**Re: Request for Modified Sediment Removal Limits
Interim Response Action Project
Diamond and Standard Chlorine Chemical Company Inc. Sites
Kearny, Hudson County, New Jersey**

INTERIM RESPONSE ACTION DESIGN
SCCC AND DIAMOND SITES
KEARNY, NEW JERSEY

SEDIMENT MANAGEMENT PLAN

FIGURE 1

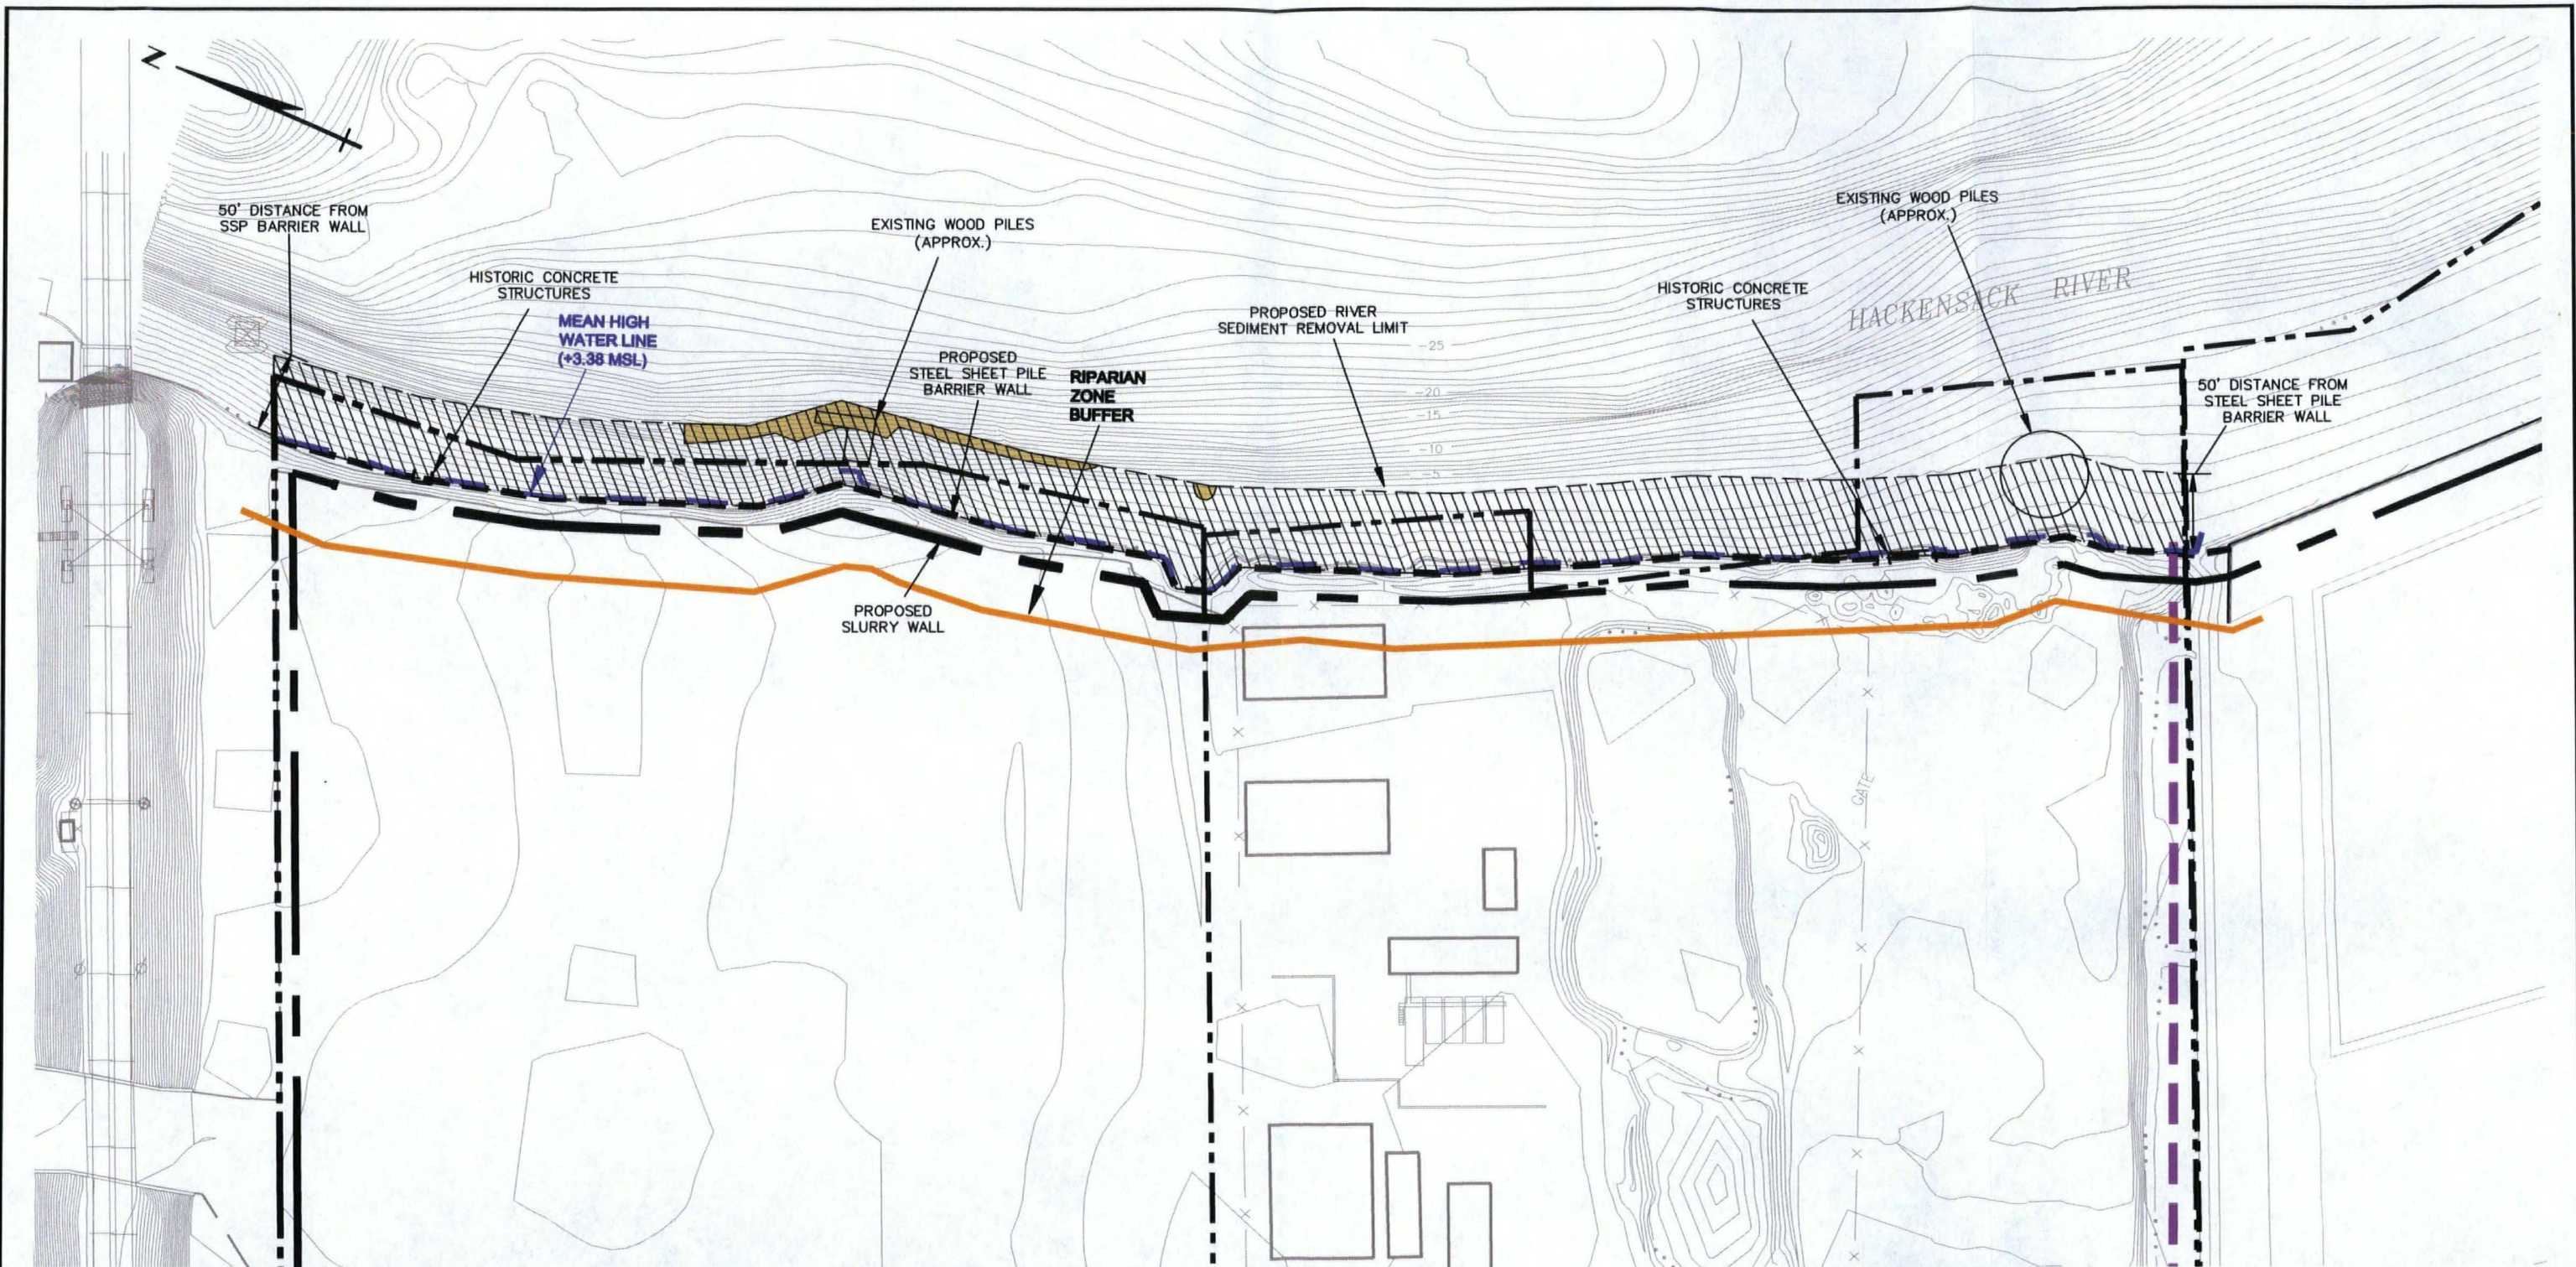
The PRG's construction contractor, WRScompass (WRS) initiated sediment removal activities within the river on January 10, 2011. To date, roughly 80 percent of the sediment removal effort has been completed, and backfilling of the excavation area has commenced. WRS has utilized a long-reach excavator to execute these removal activities, and in general has been able to achieve a 50 foot reach, and to the required depth of excavation. However, a recent bathymetric survey has demonstrated that the pre-excavation grades are roughly two (2) feet lower than expected (likely due to natural scour), and as a result, in certain areas near the offshore limits of excavation the additional depth has made sediment removal efforts relatively ineffective with the long-reach excavator. WRS made significant efforts to remedy the situation, including retrofitting the excavator bucket with a field-fabricated extension; however, given the additional required depth of excavation which is generally below the water surface, these efforts have not enabled WRS to effectively remove sediments in these limited areas. Attached Figure 1 depicts the areas in question. The areas are approximately 2,500 square feet and represent four (4) percent of the overall area proposed for excavation in conjunction with implementation of the IRAW.

We believe that with the efforts made to date the intent of the sediment removal action has been honored, i.e., excavation of near-shore sediment to the practical limitation of commonly available construction equipment. As such, at this time the PRG is requesting NJDEP's

concurrence with a proposed revision of the IRAW-specified sediment removal limits, to account for the limited problematic areas that are beyond the practical and effective reach of the on-site excavation equipment.
